# 6-30 Artarmon Road & 15 Richmond Avenue, Willoughby

S75W DESIGN RESPONSES  
Prepared for the Department of Planning, Industry and Environment

1st JUNE 2020

## 1.1 HEIGHT RESPONSE

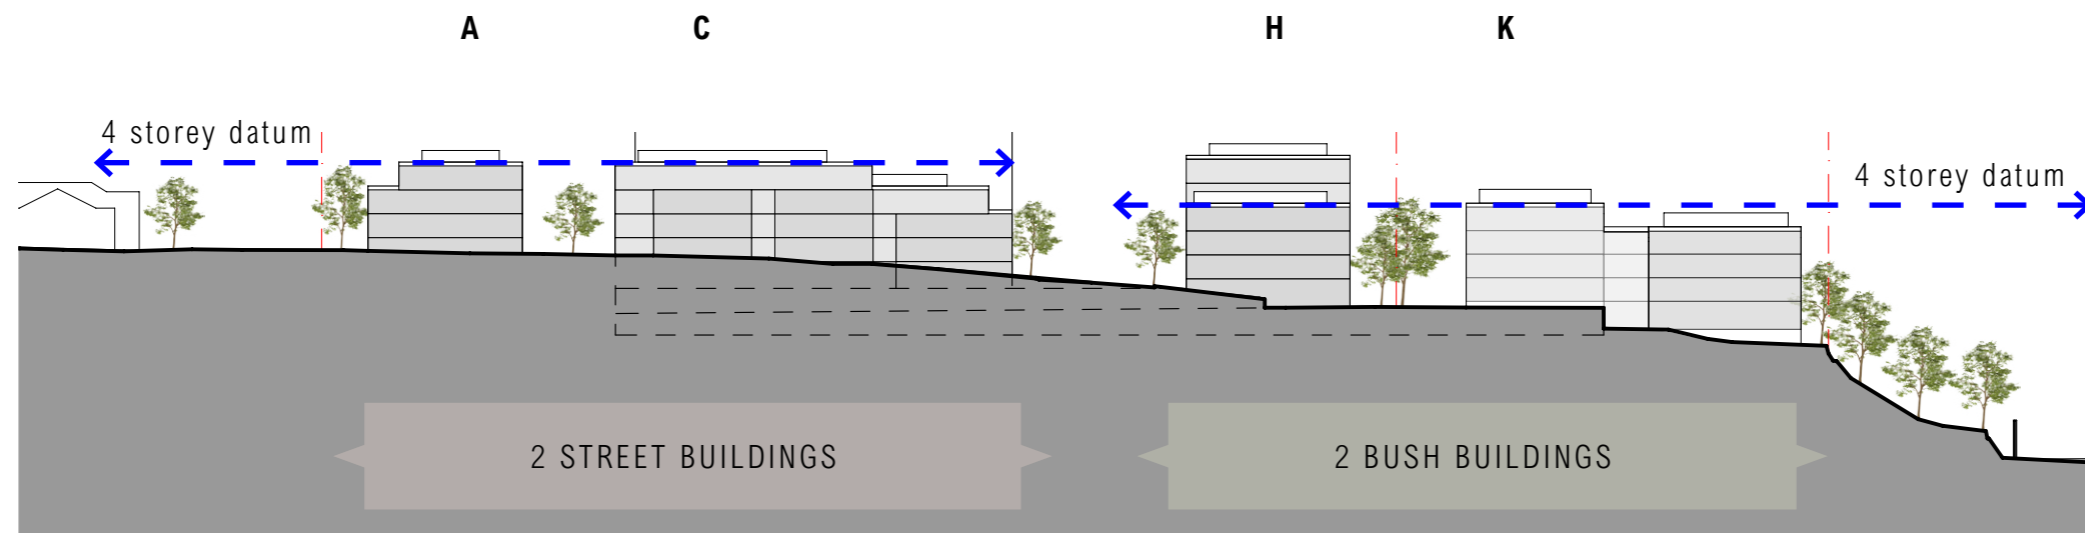
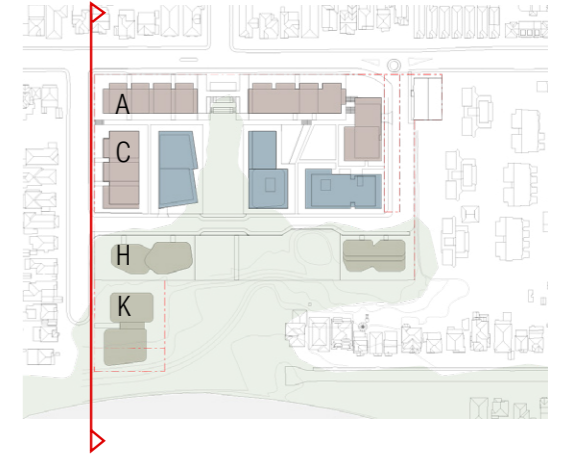
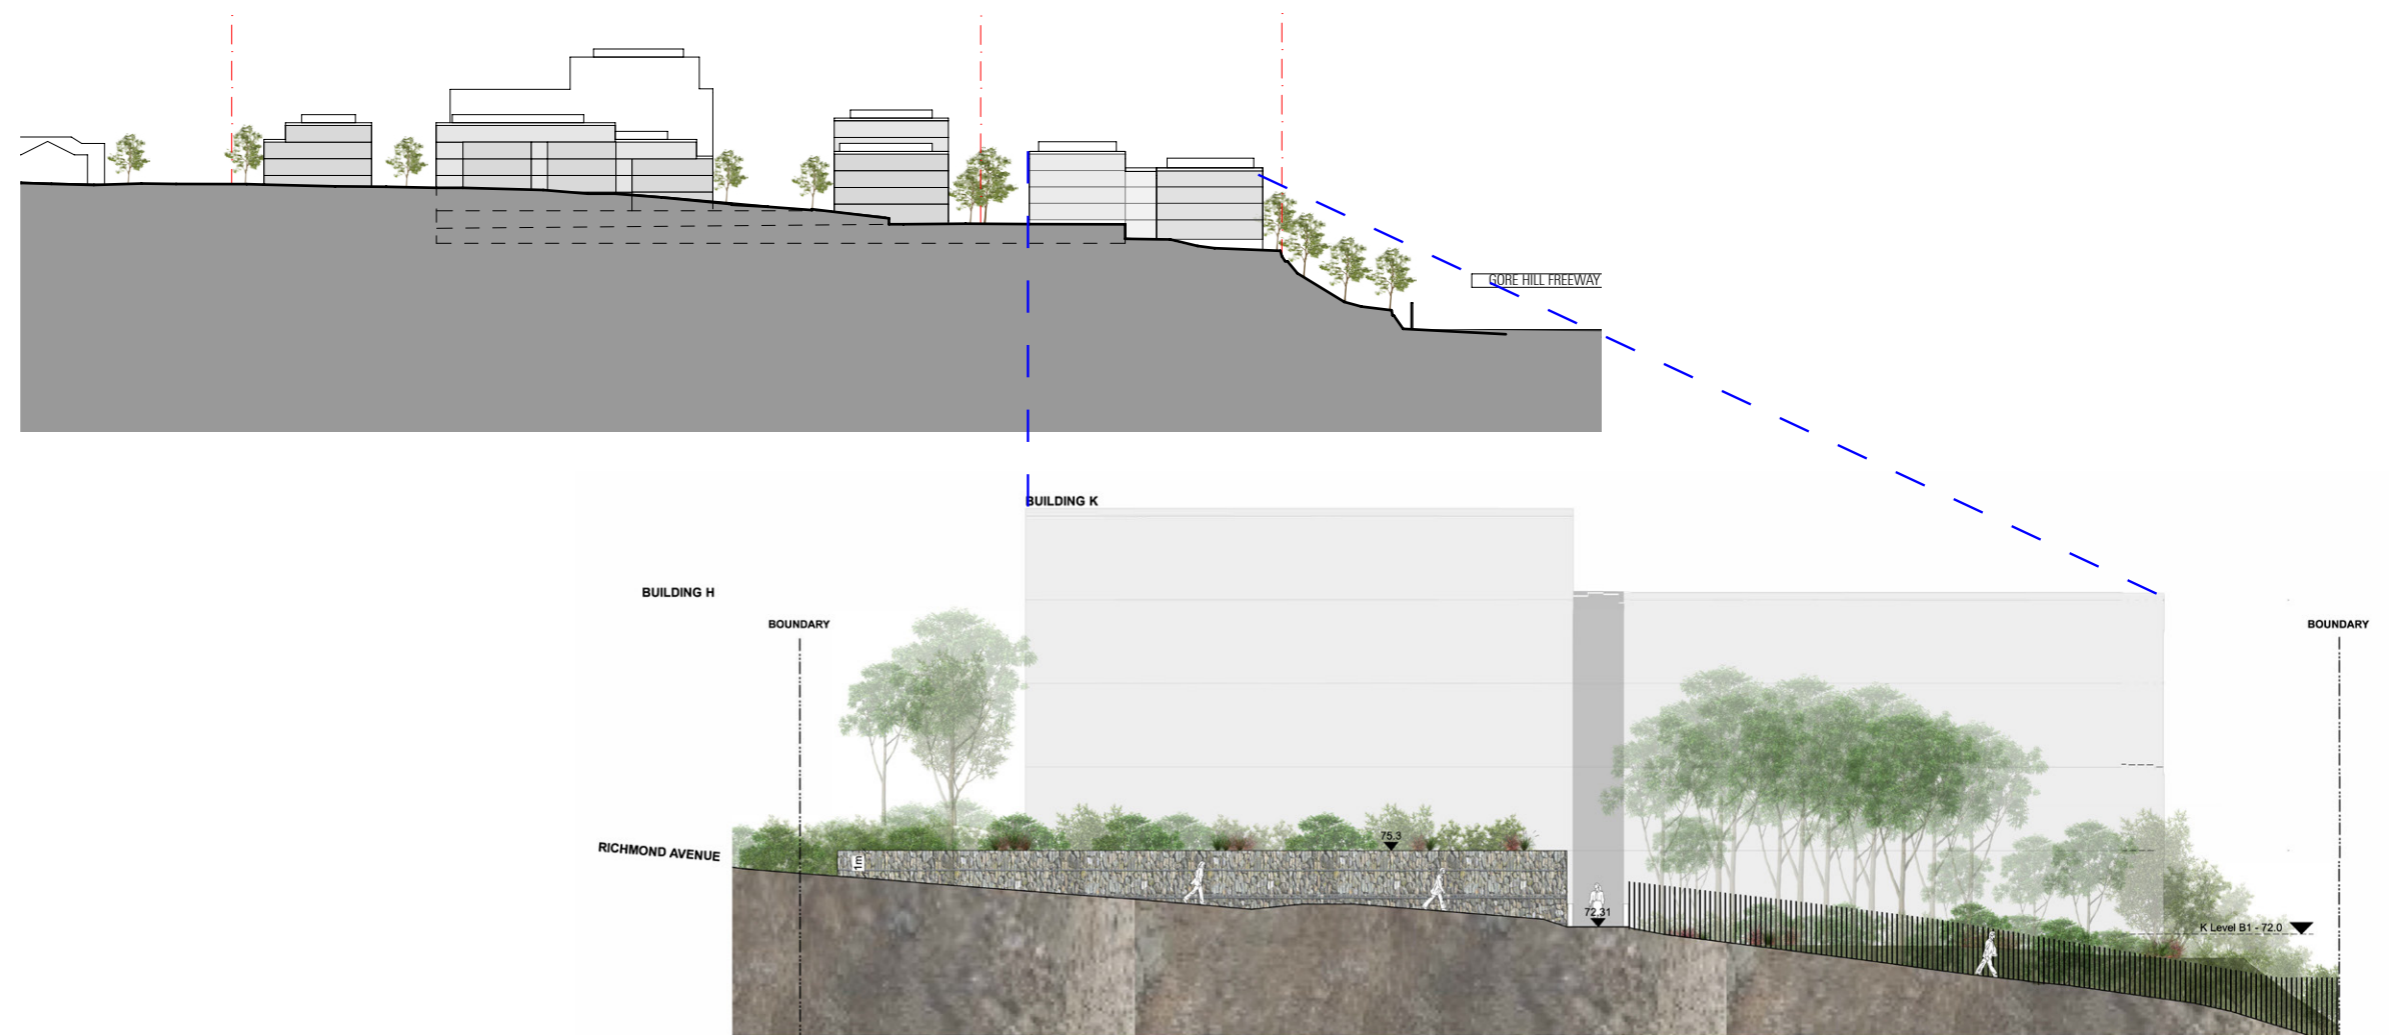
“In regards the height of the three approved buildings facing Richmond Avenue under the Concept Plan:

- Building A, on the corner of Richmond Avenue and Artarmon Road, has a parapet height of RL 93.3m and a plant height of RL 94.8m.
- Building C to the south shows a parapet height of RL 93.3m and plant height of RL 94.8m, stepping down to a parapet of RL 90.2m and a plant height of RL 91.7m.
- Building H further to the south shows a parapet height of RL 87.965m and plant height of RL 89.465m on approximately half of the building as it faces Richmond Avenue.
- The other half of Building H, further away from Richmond Avenue to the east, has an increased parapet height and plant height of RL 94.065m and RL 95.665m respectively.

The following points are noted in regards the design of Building K:

- The building is stepped in height to follow the topography of the site, being in two parts:
  - Northern section having a parapet height of RL 87.965m and plant height of RL 89.985m.
  - Southern section having a parapet height of RL 85.865m and plant height of RL 86.865m.

Consistent with the approach to height along Richmond Avenue in the approved Concept Plan, it is considered that Building K should step down with the topography of the site and be lower in height than Building H immediately to the north with both parapet and plant.”

“The building height: the proposed building is not consistent with the current Concept Plan in its relation to the low-rise buildings of Richmond Avenue or the topography of the site. The plans make the new building K look lower than the adjacent building H, but in fact the street facing part of Building H is 2 storeys lower than the rear part of Building H. Building K is set to have the same RL height as the front part of Building H, despite being downhill of it. The effective extra storey can clearly be seen in the cross section in section 3.10 (page 30) of the Urban Design Report by following the dotted lines of the car park levels compared to the ground level. This makes it out of scale with the existing buildings on Richmond Avenue. To respect the scale of the buildings along Richmond Ave (both existing and in the approved development), and the slope of the site, Building K needs to be at least one storey lower in height.

“The Department raises concern that the four to five storey Building K envelope is inconsistent with the three storey street frontage heights to Richmond Avenue established by the Concept Approval. Consideration should be given to refinements to the building envelope to ensure the building maintains an appropriate built form relationship with Richmond Avenue. Further justification is required for any elements of the building above three storeys fronting Richmond Avenue.”

As outlined in the following pages, the proposed four storey height, stepping with the street topography creates a low scaled massing which sensitively response to the streetscape.

The following design diagrams outline the proposed approach to height which included careful consideration of the proposed Richmond Ave Streetscape. The design of Building K has considered a consistent approach with the existing Concept Plan Approval as outlined in the key points below.

- The overall site masterplan considers two pairs of buildings on Richmond Avenue, one pair are street buildings and the other are bush.
- Both pairs set a 4 storey streetscape datum. These two datums step down with the topography of the street.

- Massing within each pair step on their southern edge below the datum to further respond to the streetscape.
- Street buildings setback their upper level whilst bush buildings use a greater setback to offer variation on the streetscape.

- Aligning the heights emphasises the relationship of each pair through a consistent massing approach.
- Reducing the number of stepping parapet lines along the street creates a visually calmer outcome, particularly when looking down Richmond Avenue.

- Building K ultimately results in a 4 storey building to the street. The appropriate scale sits quietly within the existing and proposed tree canopy, reducing the building's visibility from views around the local area.

Building K will present as a four storey building to the street whilst still stepping down with the sloping topography. The generous 10m and 6 m setbacks from Richmond Avenue both allow for lush landscaping treatment to further enhance the proposal's interaction with the existing street scape and topography, whilst also remaining consistent with the Concept Approval as it exists further up Richmond Avenue. Planting and gabion walls will help to step down with the massing of the street creating a high quality landscape setting. The step in the massing will align with the entry to the building.

The proposed step in height and setbacks will also help break down the scale of Building K into two masses on the street. The stepped form in plan and elevation reinforces the building's boutique scale and sympathetic response to context.

### STREET SETBACKS RESPONSE

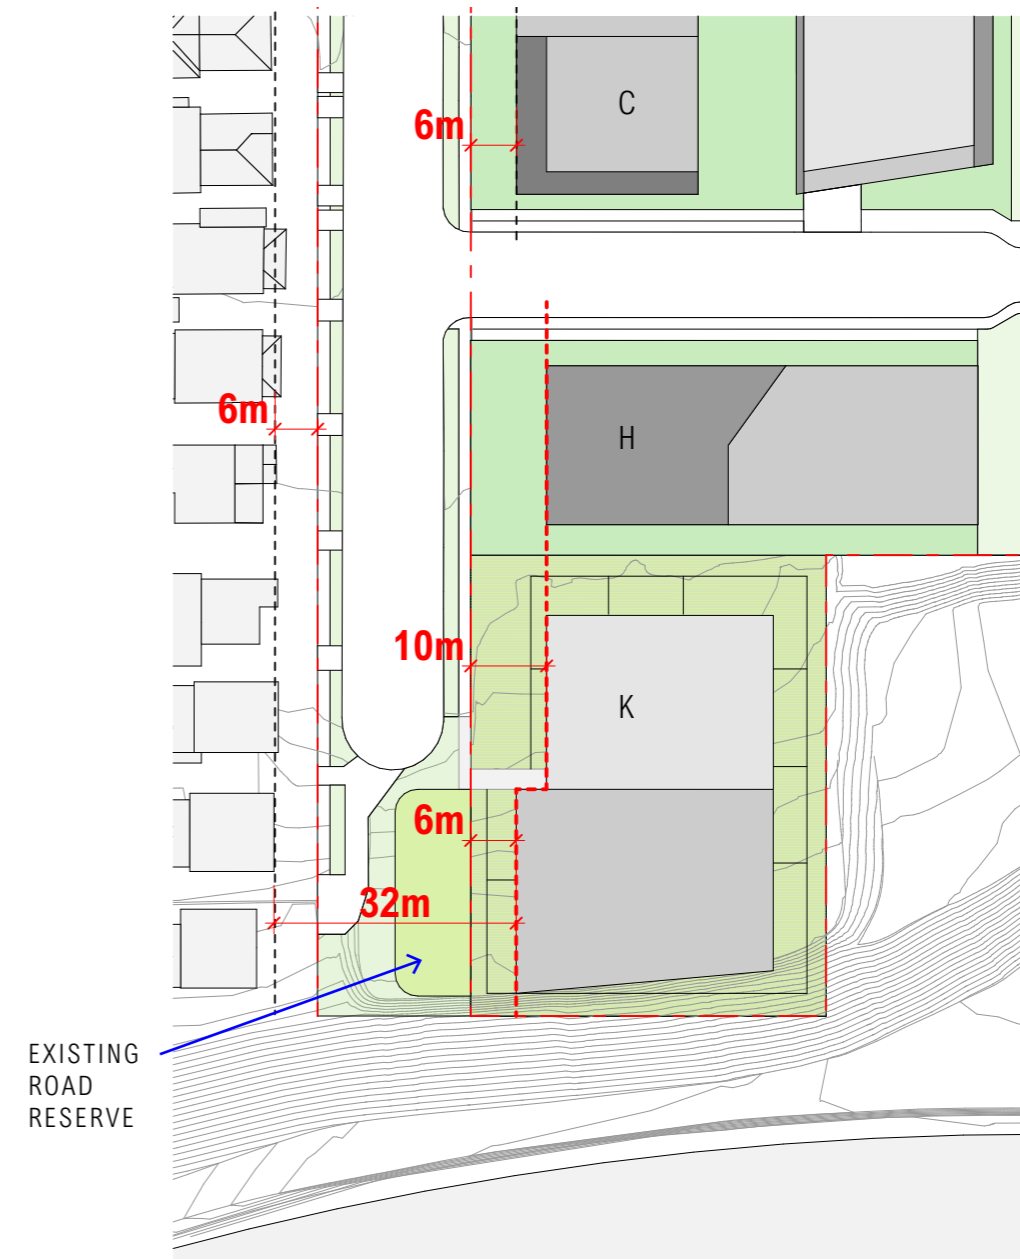
“The Building K setbacks to Richmond Avenue are provided as follows:

- Northern section having a 10m setback.
- Southern section having a 6m setback.

“The set-back from Richmond Ave: because Building H is taller than Building C to its north on Richmond Ave, it has a greater set-back of 10m rather than 6m. As Building K is of a similar height, to remain consistent with the Concept Plan and respect the relationship with the existing low-rise buildings on Richmond Avenue it needs to continue the 10m set-back throughout, rather than the southern part being only 6m.”

In the design competition and Concept Approval masterplanning process the existing setbacks for houses on Artarmon Road and Richmond Ave were carefully studied. On both existing streets there is a clear 6m predominate building setback line. This setback was then adopted for the proposed buildings on Artarmon Road and Richmond Ave in order to complete the streetscape and create a consistent and mirrored verge, footpath and landscape setting to both sides of the street.

For building K and H a 10m setback has been provided, an increase from the standard 6m to enhance the bush character and allow for more significant planting to the street. This is carried across to the northern part of Building K, creating an approximate 60m length of enhanced landscaped character along Richmond Avenue.

At the end of Richmond Avenue, beyond the end of the cul de sac, the building uses the typical 6m street setback. Here the building sits opposite the existing road reserve providing landscaped separation between the proposed envelope and the opposite driveway with a total of 32m separation between buildings. This is considered more than adequate building separation, will create good privacy, and is well in excess of the 12m building separation the ADG would require. The 6m setback will have a strong landscape design, enhancing by the existing landscaping of the bush reserve.

The differentiation in setback will also allow the Building K to be broken down and articulated into two key forms. This will be an important design strategy that will break down the scale of the building further.

SOUTHERN SETBACKS PLAN

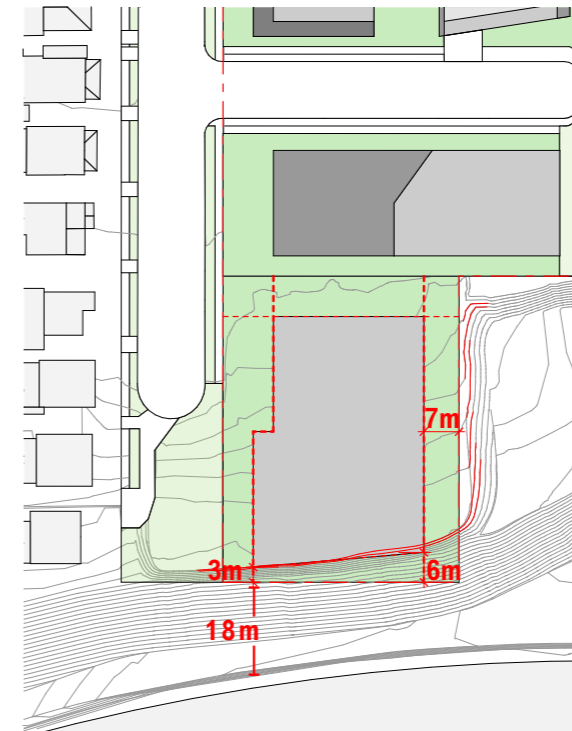
The southern side of Building K is setback 3m to the bushland located on the southern boundary for the section closest to Richmond Avenue, with the rear section having an increased set back of 6m.

The 6m setback which characterizes part of this building is considered more sympathetic to the surrounding bushland and ‘bush building’ character identified by Chrofi, broader green grid context and would be more in keeping with Council’s future plans for the embellishment of Walter Street Reserve including with contributions levied under the Concept Approval.

It is proposed that an amendment condition require a minimum 6m setback for Building K from the southern boundary.”

“Demonstrate that the setbacks enable the building to sit in a bush setting with canopy planting. In particular consideration should be given to whether the southern setback is adequate to enable trees between the building and the escarpment.”

The design approach for the southern setback creates a form that reflected the southern escarpment. The proposed 3-6m allows for access, maintenance and planting whilst allowing the built form to respond to it's context.

A Views Analysis has been undertaken as part of the Design Report which presents an acceptable outcome regarding building visibility at this proposed 3m setback from all southern viewpoints. As viewed from the south the proposed building K is not highly visible or imposing and offers a superior vista compared with the existing transmission tower creating clearer skies from all aspects.

Regarding screening from the freeway, the proposed setback allows for approximately 18m of bush screening in Walter Street Reserve land with significant trees in this area. Street views from Gore Hill Freeway demonstrate the height of these trees (refer image below). The proponent is also making significant contributions to the rehabilitation and enhancement of this reserve through the VPA .

Furthermore the setback profile allows the existing topography of the site to be celebrated, reflecting the angle of the escarpment to the south. It also provides opportunity for enhanced building articulation. The southern profile represents an optimal location to facilitate building expression where there is no interface with existing occupancies.

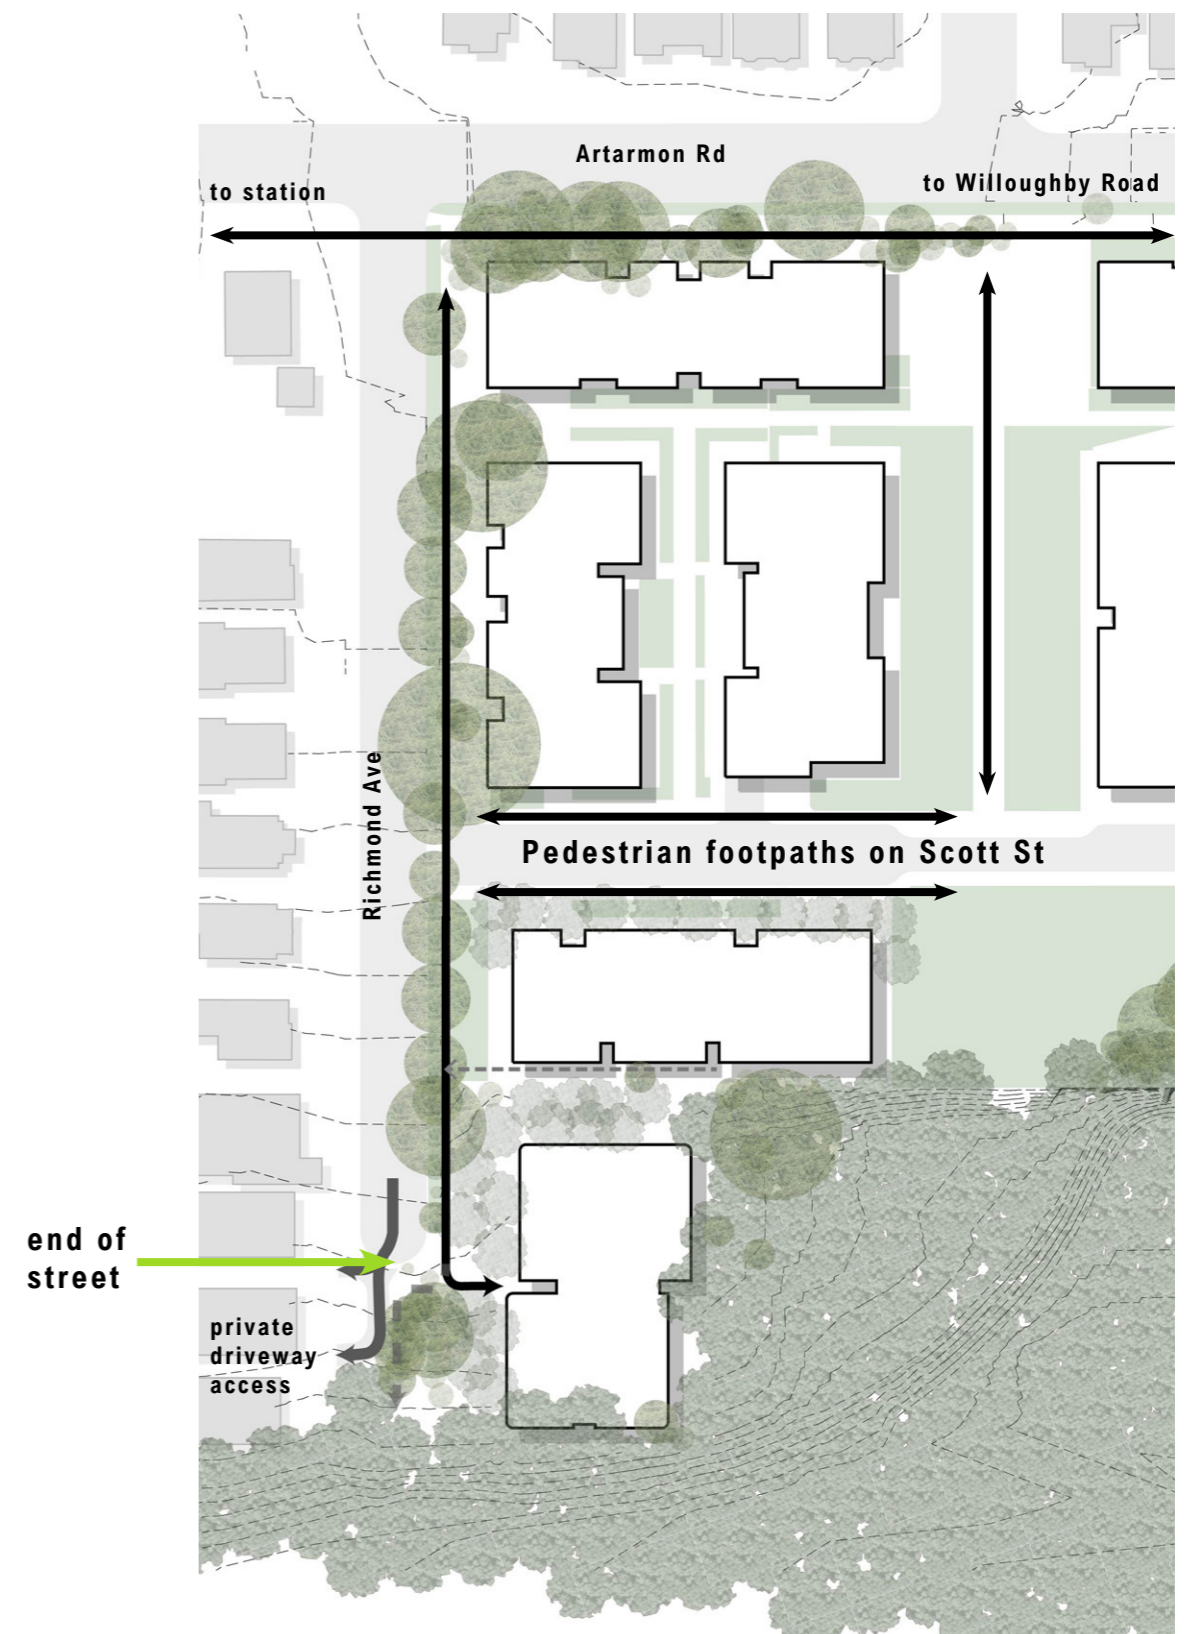
“Council seeks to maximise public access across the entire site via linkages to the larger areas of public open space within. Public access is already required under the approved Concept Plan across various sections of the overall site. In this regard, and consistent with the permeable approach already taken, pedestrian public access in the form of a right of way is requested, as a minimum, between proposed Building K and approved Building H, connecting the end of Richmond Avenue with the southern part of the central publicly accessible open space.”

Building K sits at the end of a cul de sac on Richmond Ave with no pedestrian connections to the south to either Walter Street Reserve or the freeway below.

A right of way between Buildings H and K is considered unnecessary based on the existing Concept Plans public connections, likely pedestrian desire lines, ground plane and public domain design.

For users of the public open space wishing to access Richmond Avenue, the safest and most legible connection will be to use the new Scott Street that connects directly to Richmond Avenue. This would be a similar travel distance, and a more likely path taken as most residents will be heading north to other streets and homes, rather than south towards the cul de sac end of Richmond Avenue.

If any future connection is created at the end of Richmond Ave through council owned land and Walter Street Reserve, the street will still be a similar distance to travel and will likely be the preferred path taken due to its open and safe street character, footpaths, street lighting and good passive surveillance.

A public accessway between Building H and K would also compromise the privacy and occupant amenity of respective apartments facing this zone.
